FIELD INSPECTION

Project Name:	Mountain Valley Pipeline	Inspector:	Matthew Grant
Inspection Date:	Tuesday, April 2, 2019	Project Contact:	Brian Clauto
Spread: Pittsylvania County MP294-295 St15529-15584	Spread I	Weather (Wet/Dry/Rain):	Dry

FIELD INSPECTION PHOTO LOG

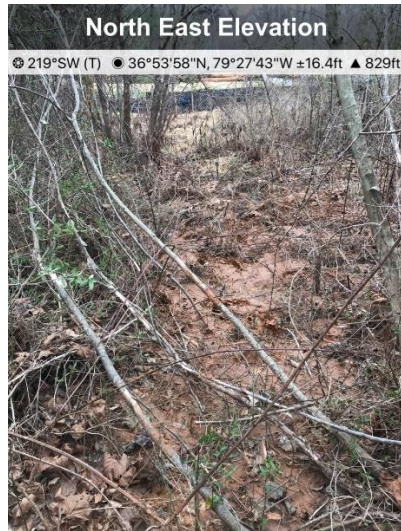
- Streams / wetlands inspected included: SCC15 SCC5, SCC19, SCC10, SCC11, W-MM5
- St#15543+00 at SCC5 buffer area CFS has a hole in the side of it
- St#15543+20 sediment off of ROW

Recommended Corrective Action: Maintain all controls per the approved plan and specs, remove sediment per DEQ approval.
